SUFFOLK ENERGY ACTION SOLUTIONS'**REBUTTAL TO NGET RESPONSE TO SEAS RR
ALTERNATIVE SITES****SEA LINK: EN020026****SEAS IP:** [REDACTED]**DEADLINE: 2 – December 9, 2025****Date: 9 Dec 2025**

This document constitutes SEAS rebuttal to the Applicant's Response to SEAS Relevant Representation [\[RR-5210\]](#), as set out in:

**[\[REP1A-043\]](#) - 9.34.1 Applicant's Comments on Relevant Representations
Identified by the ExA - Specifically Table 2.50 SEAS Alternative Sites**

Figure 1 Designated Heritage Assets

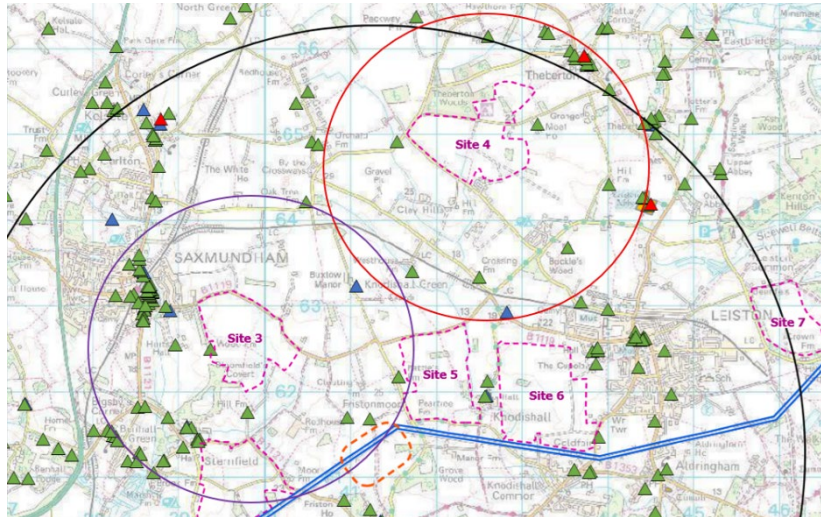
- 36 As we will show in the next section, the distances quoted in APP-368 CPRSS, figure 9.20, are subject to challenge, and will depend on the point within or on

the boundary of the site chosen as origin¹. Even so, a cursory inspection reveals that using the centre of each site, and taking the distance to the Scheduled Monument Leiston Abbey as the radius of the circle of immediate impact, there are many more heritage assets affected by the choice of Site 3 (33) than Site 4 (21) – although of course the Abbey is the only Scheduled Monument within the Study Area. Figure 1 below sets this out.

¹ Using the 1:40,000 scale at A3 on figure 9-20 in the cited document, it would appear that this is the distance from the *closest* part of the site boundary, as we would unhappily expect. The same methodology used on Site 3 would give the three nearest Designated Assets at 0m,0m, and 40m respectively. This is obviously not a useful comparison, and cannot be claimed in favour of one site over another.

Figure 2 Aerial photo from Google Earth showing Ex RAF Leiston Site (Site C as identified in Application Document 8.1 Corridor and Preliminary Routeing and Siting study - October 2022 (APP-368)) distances to homes in Leiston and Theberton

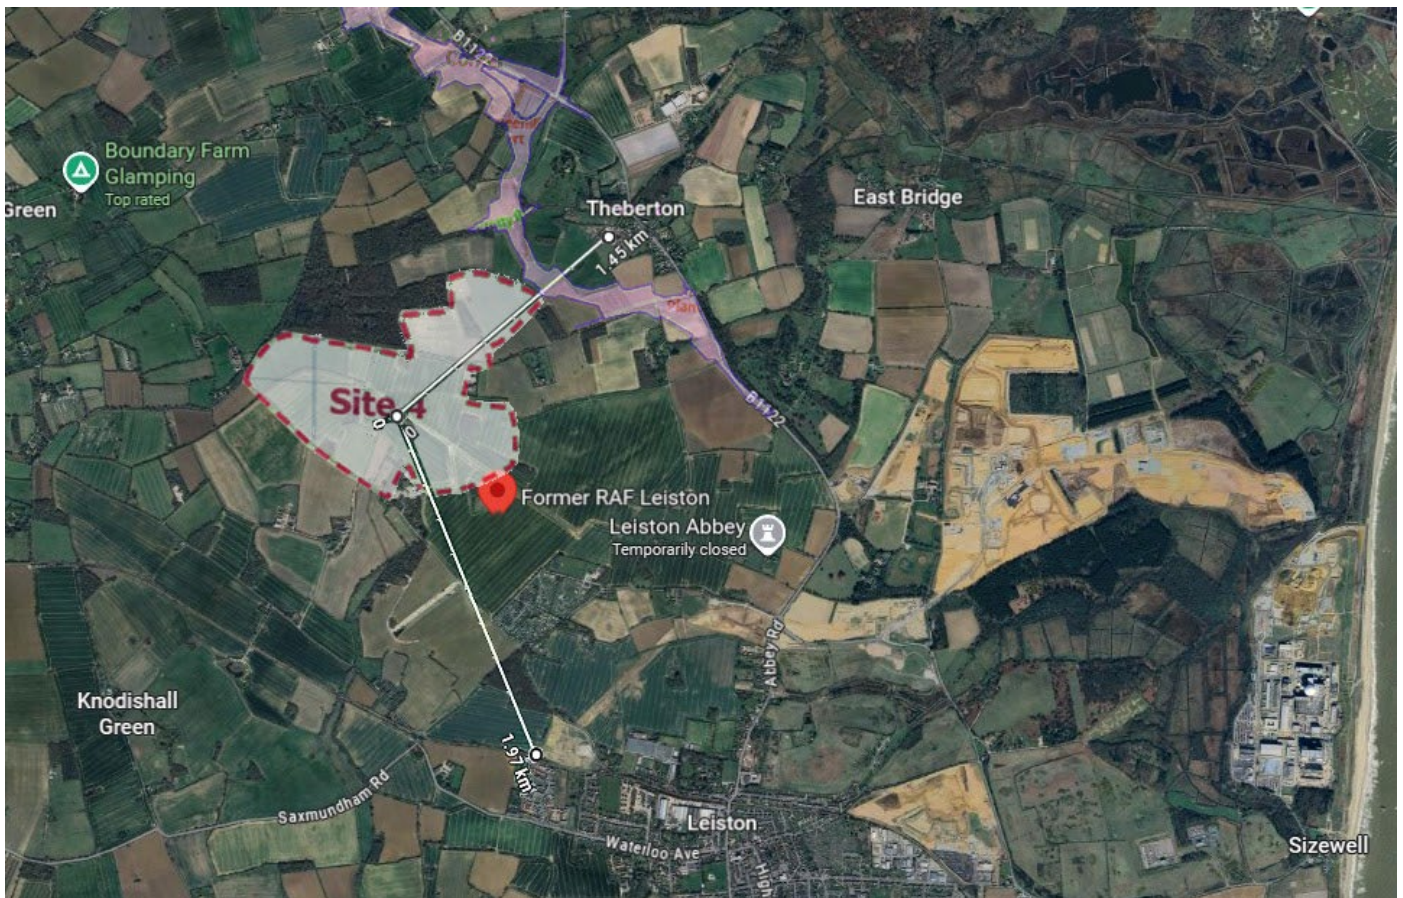
- 39 Furthermore, the comments in B.5.12 on site location are once more inept and inaccurate, and do not in any way meet our objections to NGET's preference for Site 3. Site 4 is not '...located approximately 500m from the settlement of Theberton..' – the centre of the site is about 1.45km from the nearest point of the Theberton settlement (see figure 2 in the Appendix to this submission); Site 4 is not '...[located] 1.5km from the settlement of Leiston...' – the distance is about 1.97km (see Figure 3 in the Appendix to this submission). No comparable figures are given for Site 3, but in Figure 3 we have shown that on a similar basis, the nearest settlements (in Church Hill and Wood Farm) are about 500m and 575m respectively. On this (the Applicant's *chosen* basis in this section), it is nonsensical to claim that '*...For Site 3, no significant effects on communities are identified..*'; and therefore if there is anything 'unclear' about site selection in this regard, it is the basis for Applicant's claim for Site 3.
